***Environmental Planning and Assessment Act, 1979,
As amended***
**NOTICE TO APPLICANT OF DETERMINATION OF A
DEVELOPMENT APPLICATION**

Under Section 96 of the Act, notice is hereby given of the determination by the consent authority of the application to amend Development Consent No. 545/2001 relating to the land described as follows:

15 LOT TORRENS SUBDIVISION - 7B1

being modify Condition No. 52.

WATERCOURSE #1 CYCLEWAY PEDESTRIAN AND PLAYGROUND NETWORK

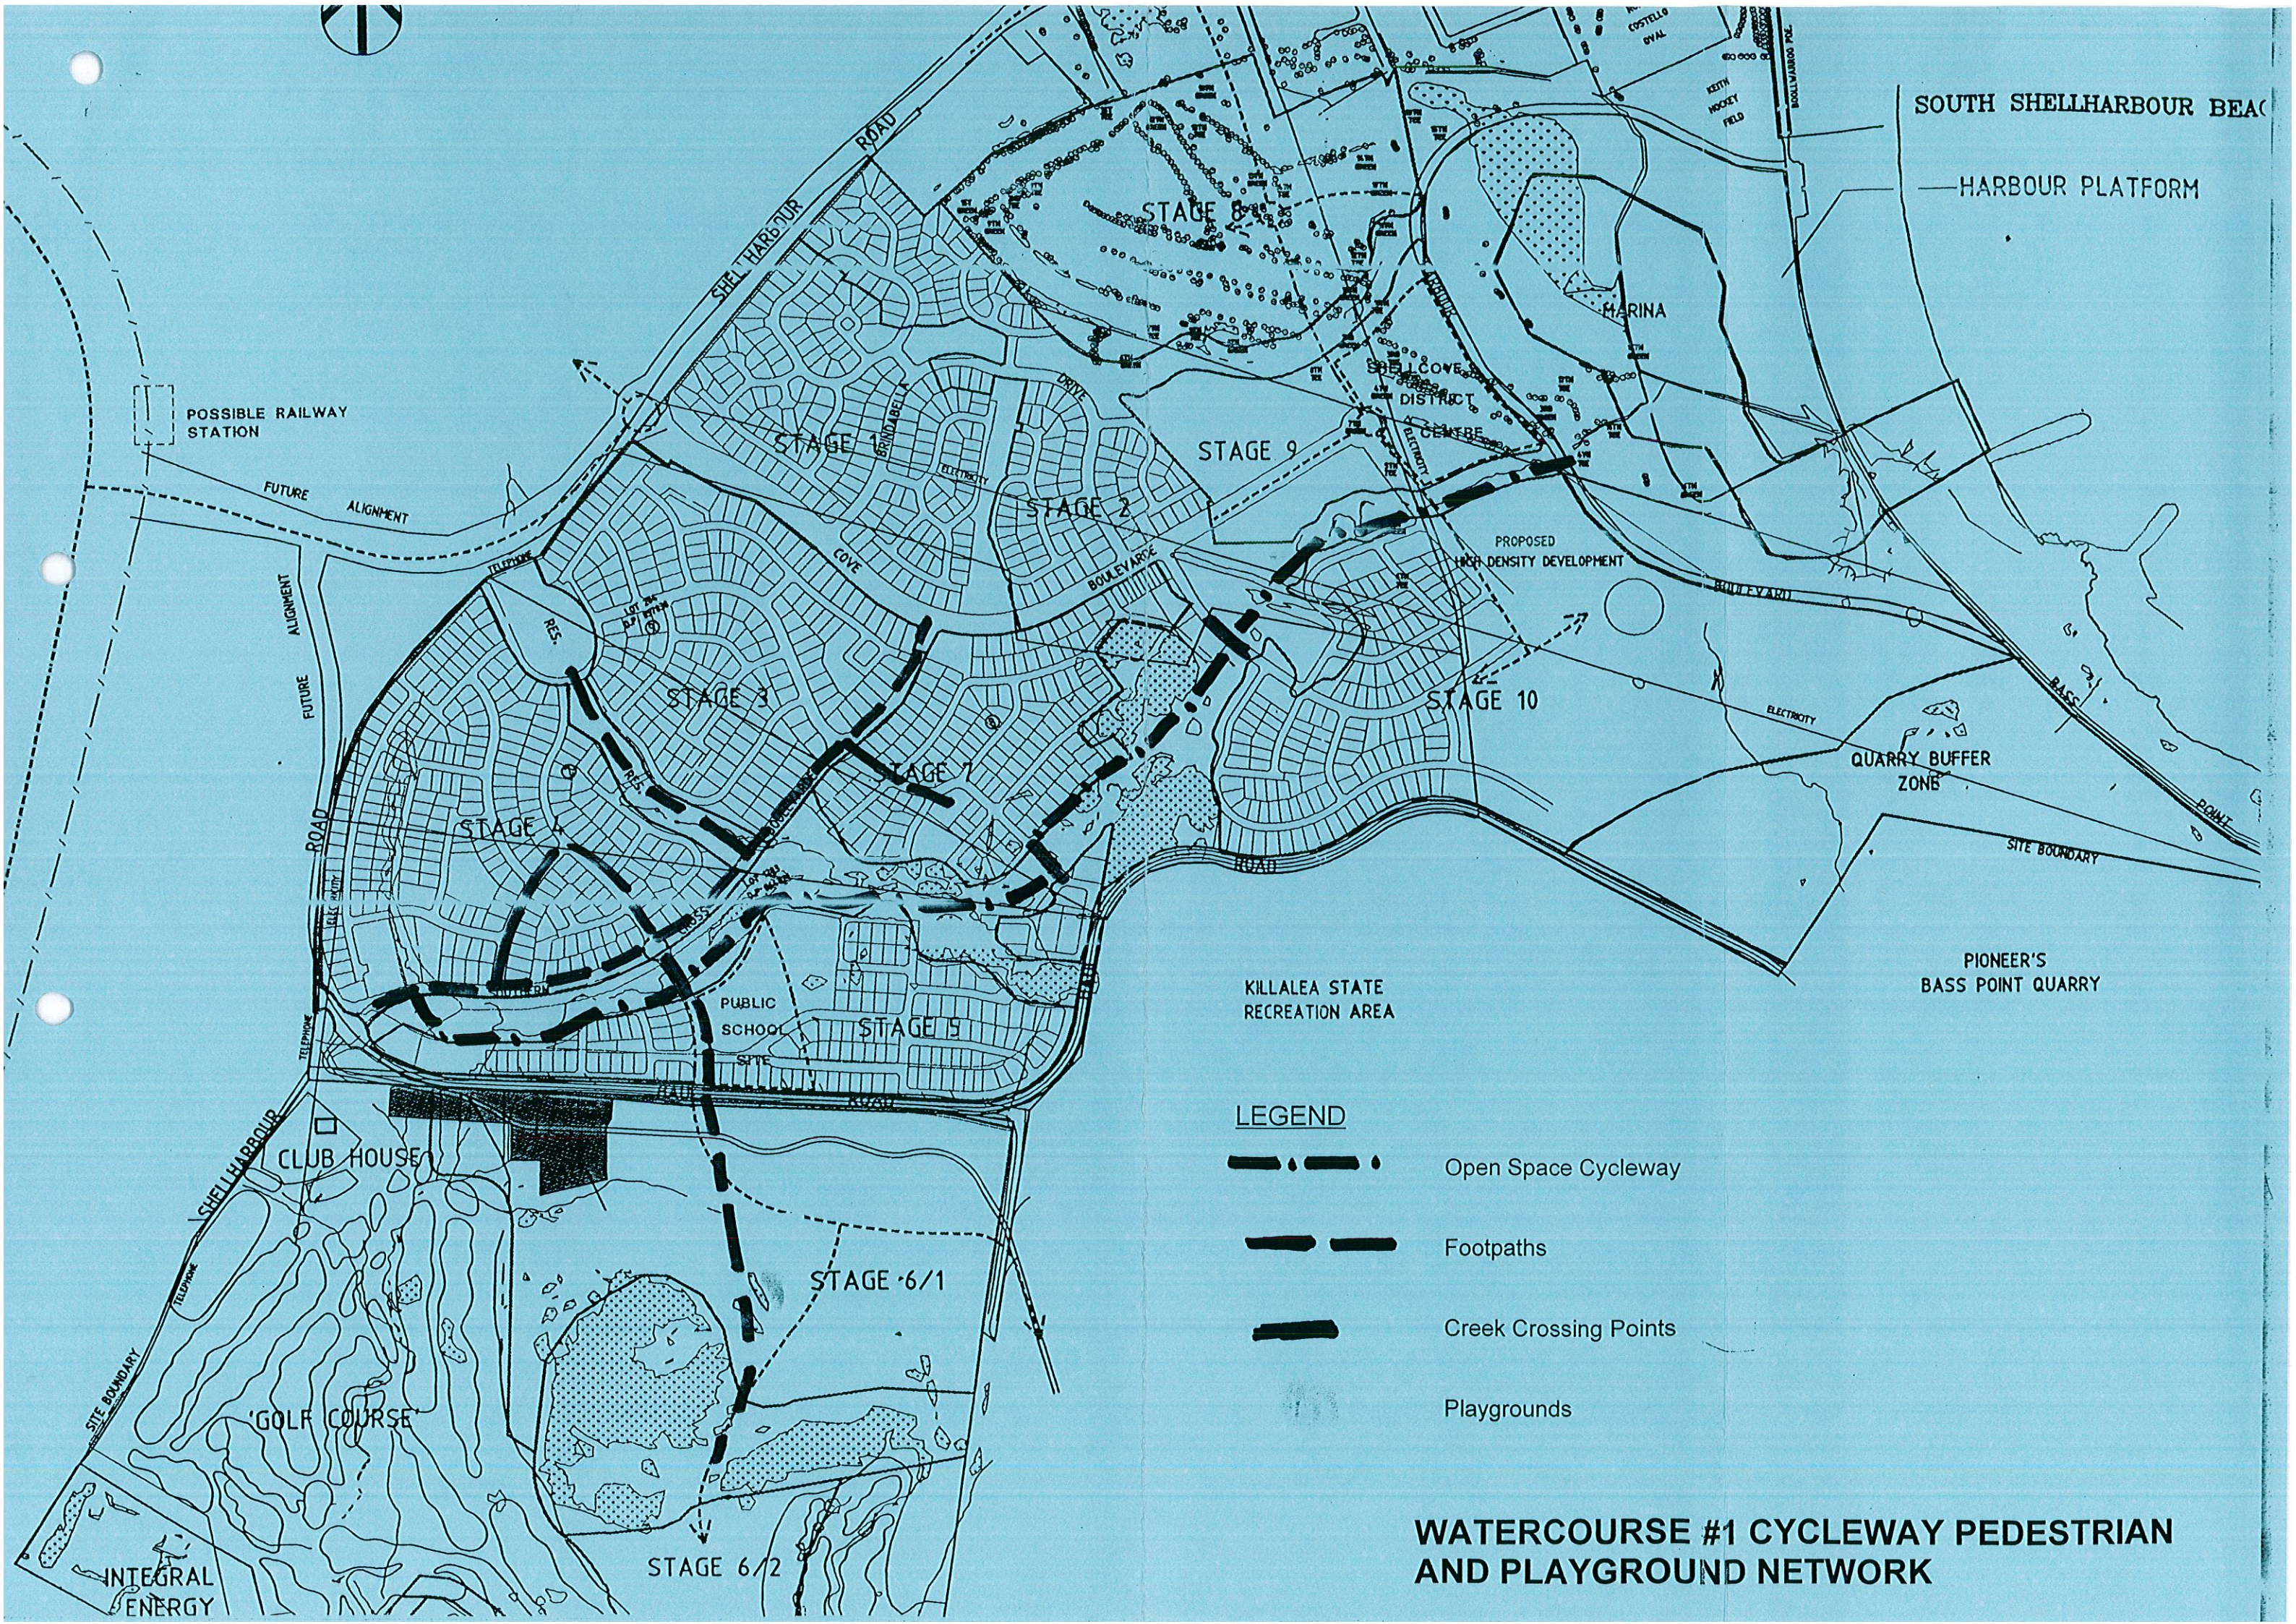
52. The developer shall submit a footpath/cycleway plan for the development, for Council's approval, in conjunction with the Construction Certificate. In this regard, a 1.2m wide concrete footpath should be constructed along the southern side of Southern Cross Boulevard between Hinchinbrook Drive and Killalea Drive. Footpaths/cycleways shall be constructed in accordance with the approved plans at no cost to Council.

-  1.2 WIDE FOOTPATH PROPOSED TO BE CONDITIONED FOR STAGE 7B1 S076 MODIFICATION
-  1.2 WIDE FOOTPATH OFFERED TO BE CONSTRUCTED BY SHELL COVE AFTER EXPIRY OF DISPLAY VILLAGE
